Technical Service Bulletin

**SCBS / SBS, LAS / LDWS, MASTER AND/OR HBC WARNING LIGHTS
ON WITH DTC U3000:98 STORED DURING HOT WEATHER**

Bulletin No.: 15-002/18

Last Issued: 07/06/2018

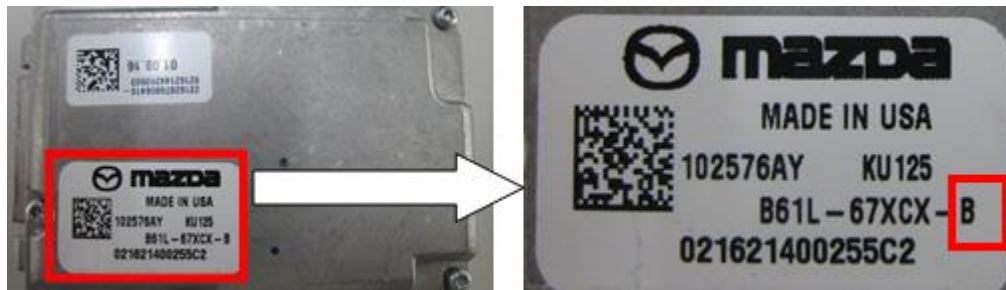
This condition may be caused by FSC control logic that is too sensitive. When the FSC detects DTC U3000:98 during high temperature, it stops the internal communication and stores DTC U3000:04. DTC U3000:04 will not clear and SCBS/SBS, LAS/LDWS, and/or HBC functions will not resume until the ignition switch has been turned OFF even if the temperature of the FSC cools.

The warning lights/messages will be displayed until the FSC cools and the ignition is turned OFF, then back ON.

Customers having this concern should have their vehicle repaired using the following repair procedure.
